Submission for Job: #4097 Project Application
https://majorprojects.onhiive.com/index.pl?action=view_job&id=4097

Site: #2291 Sydney Light Rail Inner West Extension
https://majorprojects.onhiive.com/index.pl?action=view_site&id=2291

A Submission on the Sydney Light Rail Extension Stage 1 – Inner West Extension Environmental Assessment

Illustration 3.1: Connecting the light and heavy rail networks at Lewisham

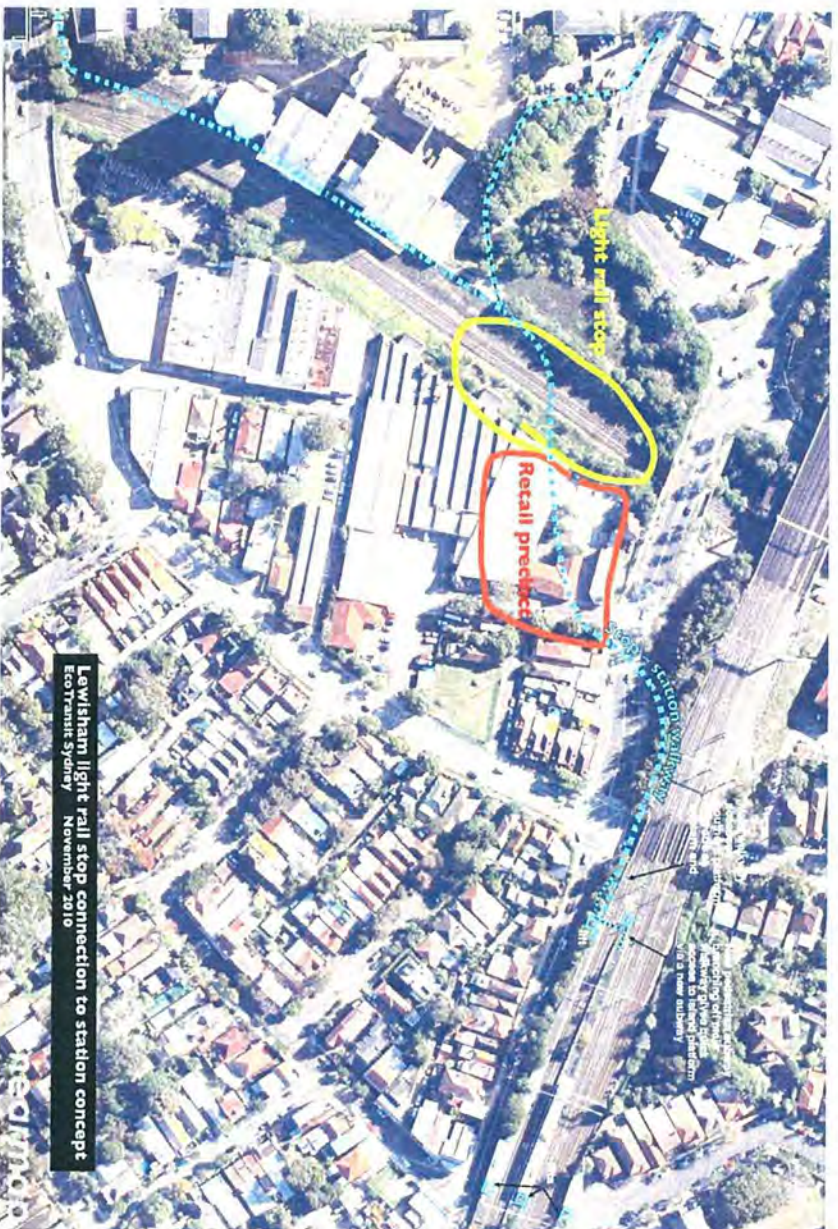
EcoTransit strongly recommends that the Lewisham West stop be moved further north to a position where it would provide the quickest, most convenient possible pedestrian link between the Lewisham West stop and Lewisham Station. This link is vital because it will enable light rail to act as a feeder to the Main Western line and as a convenient shortcut between the Bankstown and Main Western lines, thereby taking pressure off Redfern Station. Over time, and with the integration of light rail into the MyZone scheme, these functions will assume considerable importance.

In particular the pedestrian link must avoid at-grade road crossings since the surrounding roads are very busy. By locating the stop further north and applying the principles of Transit Oriented Development, an opportunity would exist for creating a shorter, more direct connection between the light rail stop and Lewisham Station.

The best, most direct route for this link is shown in Illustration 3.1. Passengers transferring from the light rail stop to Lewisham station would traverse the proposed retail precinct of the Lewisham Estate development. Passing through an active shopping precinct will offer an enhanced level of convenience and personal safety for passengers.

EcoTransit strongly recommends that Transport NSW convene a taskforce with representatives of all relevant state and local government agencies, with input from the Lewisham Estate developers to plan for and enable implementation of this scheme.

Illustration 3.3: Light rail stop coverage

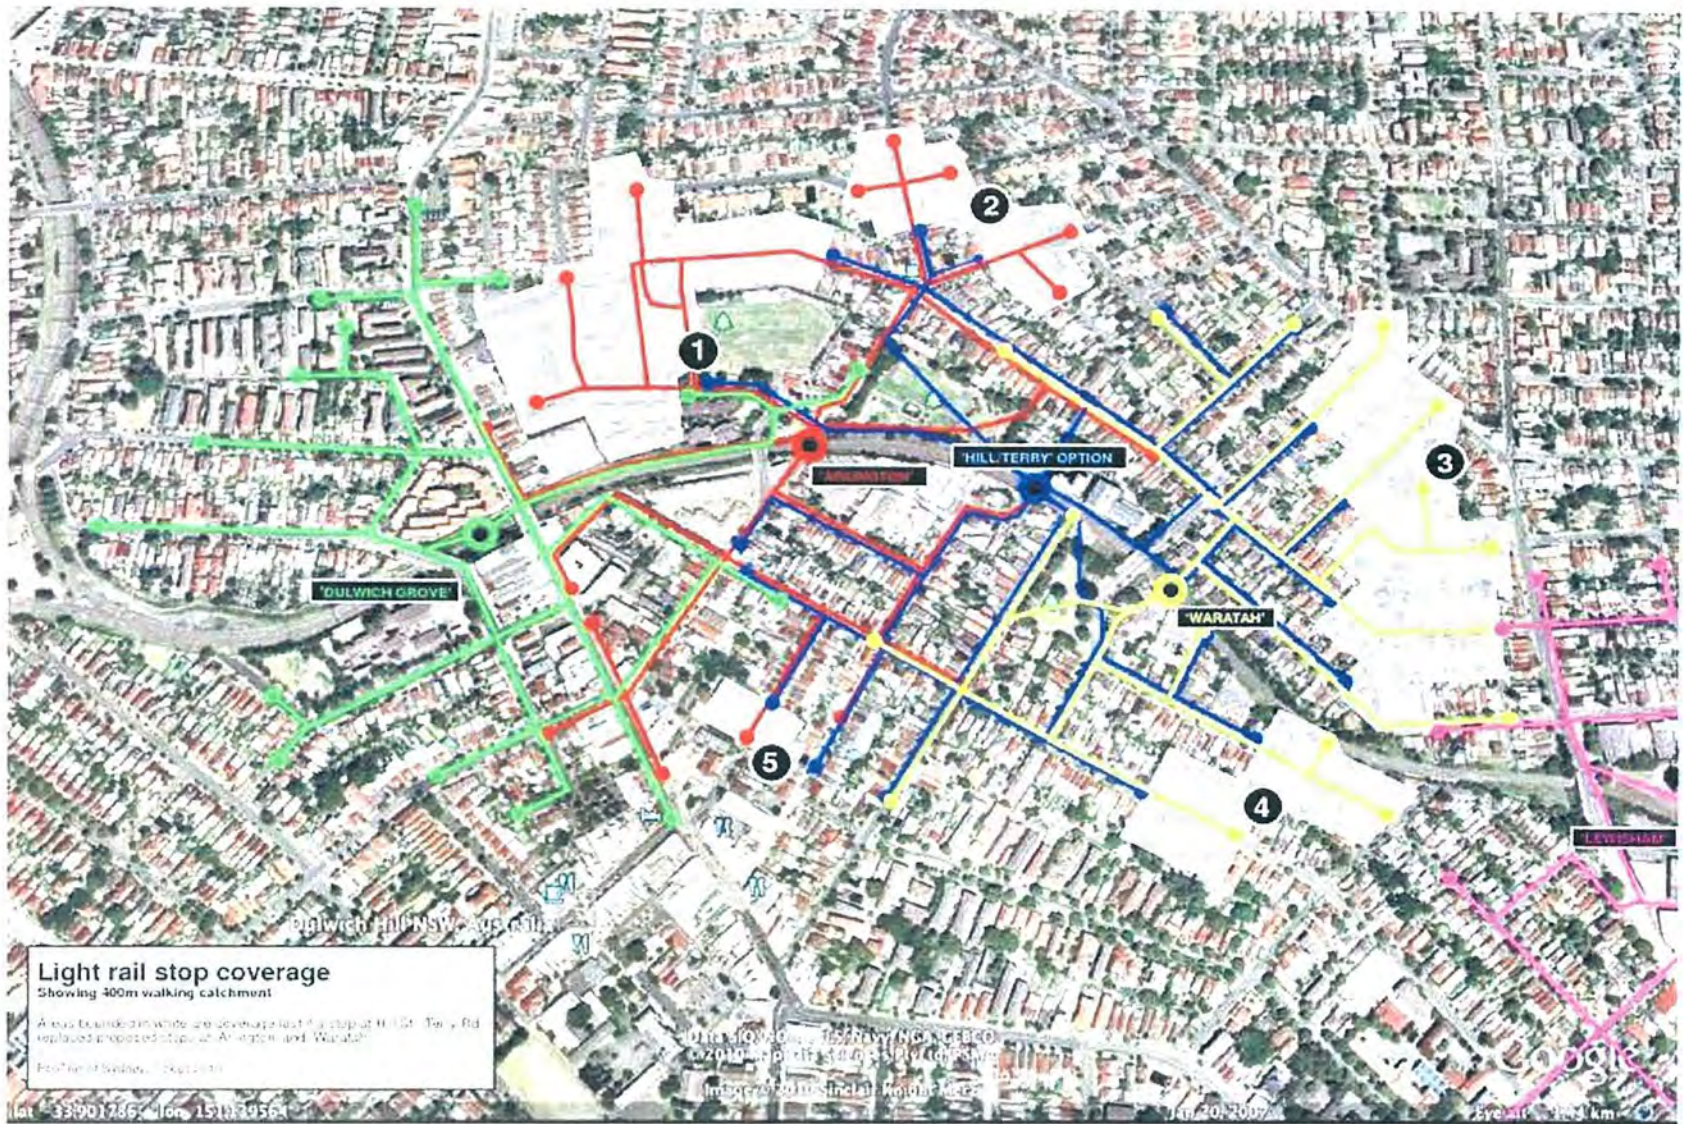
- The extensive medium density residential developments in its vicinity which would fall outside the 400m walking catchment if the Hill/Terry option were selected;
- The existence of a regionally important sporting venue and recreational facilities in the immediate vicinity;
- It services an area to the west that is inside the 800m walking catchment (e.g. Trinity Grammar School) that is not inside the 800m catchment of either of the other two adjacent stops⁶;
- The access it would provide to the Dulwich Hill shopping strip.
